Office Action Summary

10/553,457

BOHM ET AL.

DETAILED ACTION

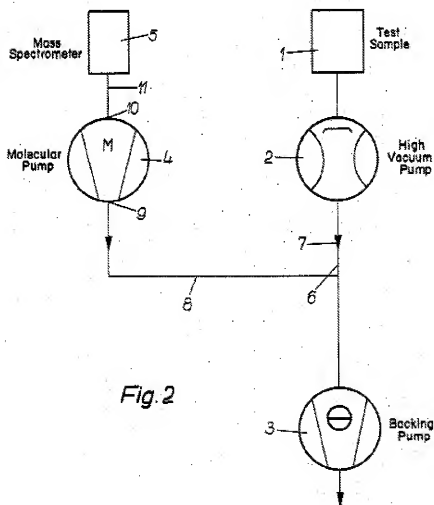
8. In Re claim 5, with reference to Figure 2 depicted above, Becker discloses a Leak detector (column 1, line 15) comprising:

- a first high vacuum pump (2) having an entry side which is inherently connected to an inlet of the leak detector (1)
- a second high vacuum pump (4) having an entry side which is connected to a mass spectrometer (5)
- a primary pump (3) having an entry side which is connected to the exit sides (9) and (7) of the first (2) and second (4) high vacuum pumps by conduits (6) and (8)
- there are no throttles or valves between the means connecting the first high vacuum pump (2) and the inlet of the leak detector (1)

9. However, Becker does not disclose a bypass with a first valve and a second valve between the first high vacuum pump and the primary pump.

FIG.1

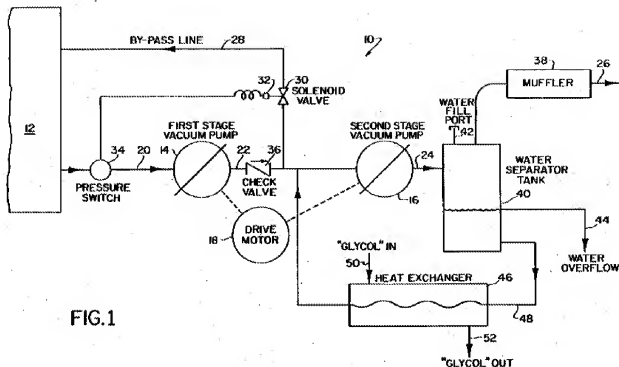
10. Nevertheless, with reference to Figure 1 depicted above, Alloca et al discloses a vacuum pumping system comprising:

- a first high vacuum pump (14) having an entry side which is inherently connected to a vacuum chamber (12) in a non-throttled manner without valving
- a bypass (28) with first valve (30) connecting vacuum chamber (12) to the primary pump (16)
- a second valve (36) provided between the exit side of the first high vacuum pump (14) and a primary pump (16)

- modify the leak detector of Becker to include a bypass line with a first valve connecting the inlet of the leak detector to the primary pump as taught by Alloca et al for the purpose of relieving interstage pressure, thereby lowering the power draw on the drive motor as taught by Alloca et al as stated in column 2, line 67 to column 3 line 2.
- further modify the leak detector of Becker to include a second valve provided between the exit side of the first high vacuum pump and a primary pump as taught by Alloca et al for the purpose of preventing back pressure on the first high vacuum pump as taught by Alloca et al as stated in column 3, lines 20-21.

FIG. 1

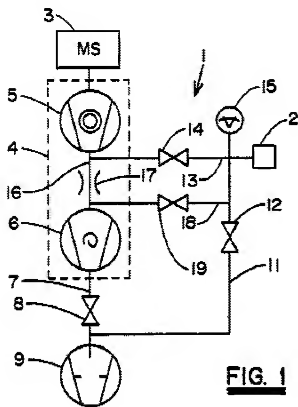
14. However, with reference to Figure 1 depicted above, Grosse Bley et al discloses a leak detection unit (1) comprising:

- a second high vacuum pump (4) with two stages (5) and (6)
- intermediate inlet (13) with valve (14)

- intermediate inlet (18) with valve (19)
- valves (14) and (19) are initially closed, and are "controlled" by opening them once forevacuum pressure ("pressure on the exit side") has been attained (see column 3, lines 29-36)

15. It would have been obvious to a person having ordinary skill in the art at the time of the invention to further modify the Leak detector in Becker modified by Alloca et al, as applied to claim 5, to include the intermediate inlets and valves from the second high vacuum pump as taught by Grosse Bley et al for the purpose of increasing the sensitivity of leak detection as taught by Grosse Bley et al as stated in Column 3, line 37.

Fig. 2

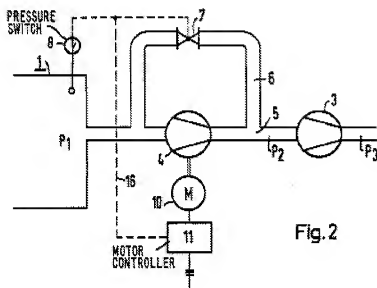
19. Nevertheless, with reference to Figure 2 depicted above, Mugele et al discloses a pump set comprising:

- a first high vacuum pump (4) having an entry side which is inherently connected to a vacuum chamber (1) in a non-throttled manner without valving
- a bypass (6) with first valve (7) connecting vacuum chamber (1) to the primary pump (3)

20. It would have been obvious to a person having ordinary skill in the art at the time of the invention to modify the leak detector of Becker to include a bypass line with a first valve connecting the inlet of the leak detector to the primary pump as taught by Mugele et al for the purpose of avoiding inadmissibly high power consumption as taught by Mugele et al as stated in column 3, line 22.

24. In Re claim 7, Mugele et al discloses in column 3, lines 14-22 that the first high vacuum pump (4) is activated by starting motor (10) when the pressure has reduced below a "limit value" of 40 Torr, after the first valve (7) has been opened enabling the primary pump (3) to achieve a sufficient vacuum.
